**CITY OF
PARRAMATTA**

SUBMISSION

In response to the exhibition of the State
Significant Development Application for the
Telopea Stage 1A and Concept Plan
22 November 2021

Figure 2 Location of proposed public spaces (extract from Appendix N)

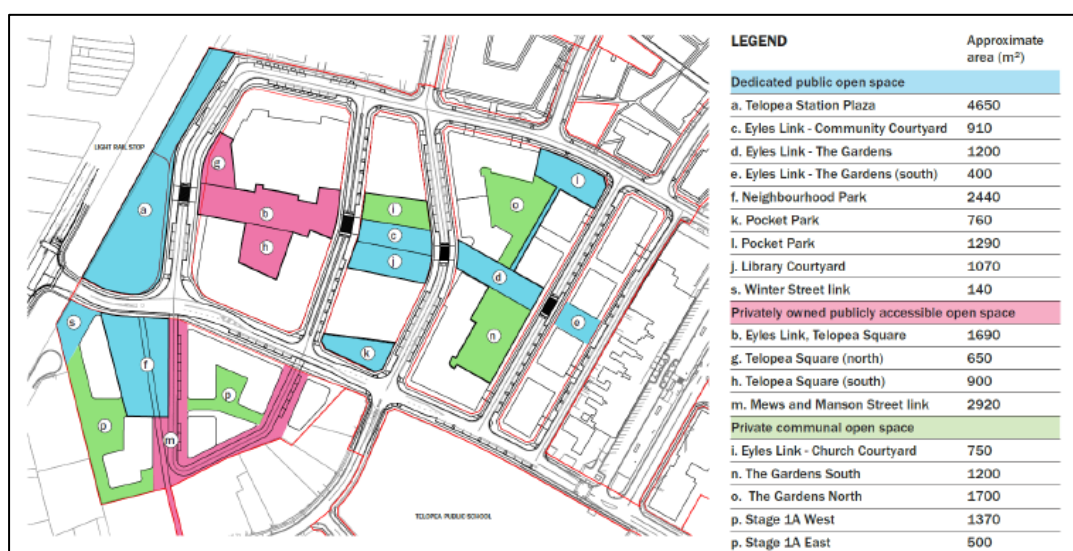
Council requires any open space to be dedicated to Council to have no basements to be located below, that is Areas C, J and K.

Council is supportive of the delivery and dedication of a neighbourhood park associated with the residential development for Stage 1A- (refer item 'f' in Figure 2). However the following issues are required to be amended before Council agrees to its dedication:

Council is supportive of the delivery and dedication of the Station Arrival Plaza (refer item a at Figure 2) at the Telopea Light Rail stop, however the following issues are required to be amended before Council agrees to its dedication:

In relation to the Library Open Space / Community Courtyard (Items c & j, Figure 2), Council supports best practice to function as a contiguous 'public' open space under a single landowner / manager. It is recommended to consolidate as a single central 'public' open space to maximise size, useability and solar access through:

- Incorporating 'Church courtyard' (refer item 'i' Figure 2).
- Adjusting Building C3 podium and tower towards Sturt Street to increase central open space (i.e. reduce area of item 'k' Figure 2). Sturt Street pocket Park (item 'k') has limited useability due to small size (<1000m²). Its poor solar access and proximity of underground carparking likely to impact ongoing viability of retained trees.

In relation to the Shortland Street Pocket Park (Item 'l' Figure 2) Council recommends incorporation of pathway edges to clearly delineate the public and private interface with the adjoining communal open space.

Council does not support open space between New Marshall Road and Benaud Lane (refer items 'd' and 'e' in Figure 2) as 'open space', for the following reasons:

- By closing the street, universal access will be required to be accommodated and due to the topography and narrowness of the site will require significant ramping which would negate any the benefits of the proposed open space;
- It does not meet Council's requirements for public open space, as it borders with private communal open space (which causes interface issues) and not public streets; and
- As detailed above, is not consistent with the street layout envisaged by the Telopea Master Plan 2017 and subsequent rezoning.

Council believes a better outcome is maintain these areas as a public shareway or laneway dedicated to Council to reflect primary 'access' purpose and accommodate additional street parking.

Figure 3. Plan indicating extent of public open space and encroachment of basement.

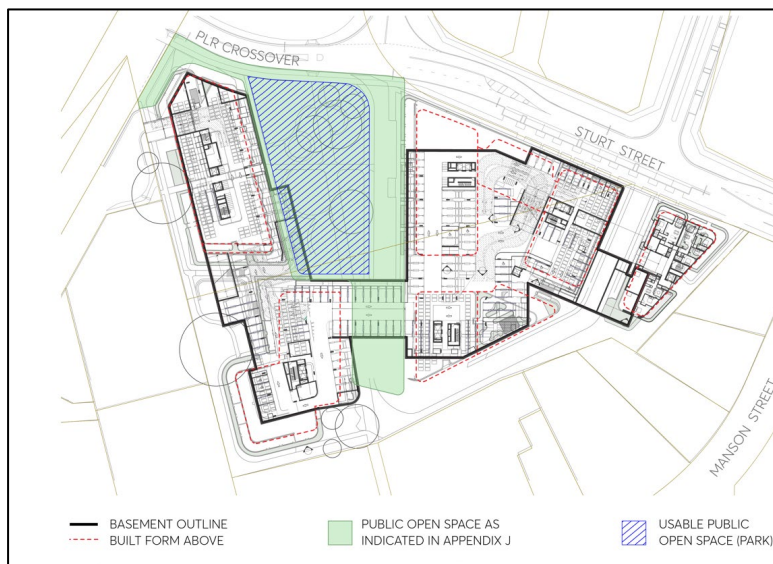
2. Removal of the underground carparking that encroaches along the south-western interface (refer Figure 3 below) and is to be removed to ensure deep soil throughout.
3. Design amendments as detailed in **Attachment B** Technical Assessment.
